# Access Compliance Report

## Public Rights-of-Way

Intersection ID: 22103	Main Street: BRANDENBURG_CT	Cross Street: HIGHVIEW_RD	Location: N
ADA ID: FC21B988FAE4	Ramp Type: PerpDiag	Initial Pass/Fail: Fail	Overall Compliance: No
			Severity Score: 46.25

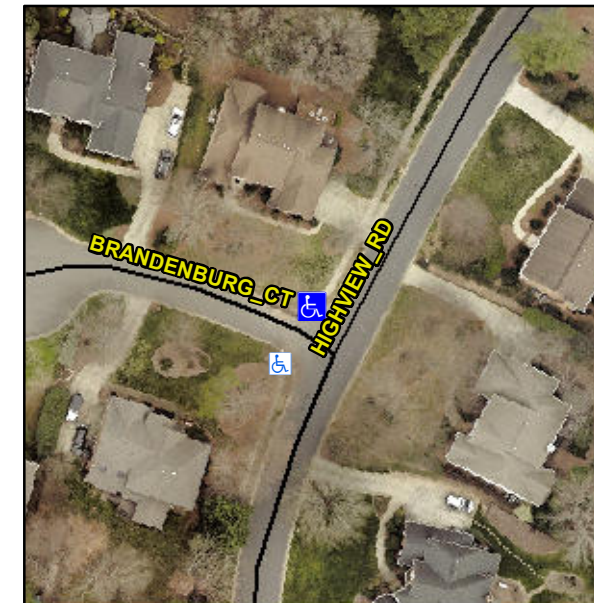
**Not Found, R304.5.1, R304.2.2, R304.5.3**

Compliance	Description	Data	Compliance	Description	Data
N/A	Ramp Length (in)	100.0	No	Ramp Slope (%)	8.6
No	Ramp Width (in)	39.0	No	Ramp XSlope (%)	7.7
N/A	Flare Type LT	N/A	N/A	Flare Type RT	N/A
N/A	Flare Slope LT (%)	N/A	N/A	Flare Slope RT (%)	N/A
N/A	Flare Traversable LT?	N/A	N/A	Flare Traversable RT?	N/A
N/A	Landing Length (in)	N/A	N/A	DWS Provided?	N/A
N/A	Landing Width (in)	N/A	N/A	DWS Contrast?	N/A
N/A	Landing Slope (%)	N/A	N/A	DWS Length (in)	N/A
N/A	Landing X Slope (%)	N/A	N/A	DWS Full Width?	N/A
N/A	Landing Curb? (Y/N)	N/A	N/A	DWS Offset (in)	N/A
N/A	Shared Landing?	N/A			
N/A	Gutter Ponding?	N/A	N/A	Gutter Slope (%)	N/A
N/A	Gutter Lip Ht (in)	N/A	N/A	Gutter X Slope (%)	N/A
N/A	Painted X Walk1?	No	N/A	Painted X Walk2?	No
	X Walk 1 Direction	To SW		X Walk 2 Direction	To SE
N/A	X Walk 1 Width (in)	N/A	N/A	X Walk 2 Width (in)	N/A
	X Walk 1 Slope (%)	2.7		X Walk 2 Slope (%)	3.5
	X Walk 1 X Slope (%)	3.1		X Walk 2 X Slope (%)	6.0

**Remove & Replace Curb Ramp With Two New Directional Ramps or Equivalent.**
